SERVICE BULLETIN #30

SUBJECT: RETRACTABLE FLOAT MAIN GEAR MECHANISM - MANDATORY

TO: ALL KITFOX AIRCRAFT OWNERS WHO OPERATE RETRACTABLE FLOATS, 1100 series, Serial No.s 01L0492 through 44L0493.

# FRONT VIEW OF MAIN LANDING GEAR

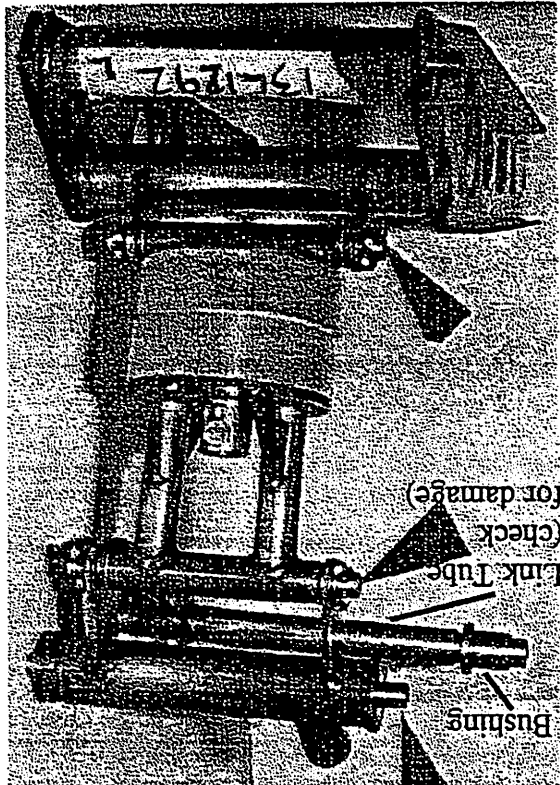
It has come to our attention that it is possible to damage the retraction mechanism during the rigging of the floats. The problem has only affected the left float mechanism at this time. Two situations have occurred during the initial rigging of the floats and to date there have been no failures arising from flight operations with the floats. This situation arises when the left float gear retraction cables are set to 30 pounds tension and then the right float right float gear retraction cables are adjusted next in sequence to 30 pounds tension. If the gear retract cables are rigged such that the left float gear reaches it's down and locked position prior to the right float gear reaching it's down and locked position, damage to the left float gear retraction mechanism is likely. The damage can occur when the left float gear is down and locked, but additional movement of the johnson bar is necessary to move the right float gear to the down and locked position. This additional movement of the johnson bar will indeed move the right gear to it's down and locked position, but it will also pull the cables attached to the left gear. The left gear cannot be moved any farther because it is already down and locked. When this happens, the link tube (part of the retraction mechanism for the left float gear) is likely to be overstressed. Subsequent operation of the landing gear retract mechanism will no longer move the left gear fully to it's down and locked position.

All amphibious float owner/operators must check their gear retraction cable rigging per the attached instructions to make certain that the cables are rigged properly, and that the right and left gears reach their down and locked positions simultaneously. Both the right and the left link tubes (see attached drawing) must be inspected for evidence of bending or twisting. In addition, the main gear over center travel must be checked per the attached drawing to make certain that sufficient over center travel exists. The gear retraction cable rigging must be checked at 100hr intervals thereafter to insure that the cables have not gone out of rig.

1. Support the floats on blocks.
2. Remove the main wheel assembly through the center opening in the float.
3. Note: place a straight edge so it runs from the center of the bottom shock pin holder and the center of the yoke tube as shown in drawing. Measure the distance from the straight edge to the center of the top shock pin. If necessary, the stop may be removed and shortened by grinding to gain sufficient over center movement. Refer to Fig. "A" to determine where to grind. Ensure over center is 1/8" to 3/16". See Fig. 1.

4. If it is necessary to replace the left float link tube, then loosen the retraction cables. It is not necessary to remove cables or their pulleys from their mounts. Remove the two AN3C10A bolts which hold the #5060 link tube. One bolt holds the pulley mount #5041 and the other attaches the pin link tube #5042. Remove the parts from each end of the link tube and save the o-rings and washers.

5. Remove the bolt holding the link tube to the link arm and remove the link tube.
6. Re-assemble in the reverse order of the above. Ensure that the o-rings and retaining washers are greased and in the original position.

7. See the attached rigging instructions for model 1100 AM Floats.
8. Check the aircraft per the float installation instructions to be certain that the float cable tension which holds the gear against the stop is at 30 +/- 2 pounds. It is very important to gradually rig the floats at the same time and to make certain that the left and right gears operate in unison. Do not force the retract handle in the down position without monitoring the cable tension. The handle and lever have enough leverage to twist the linkages.
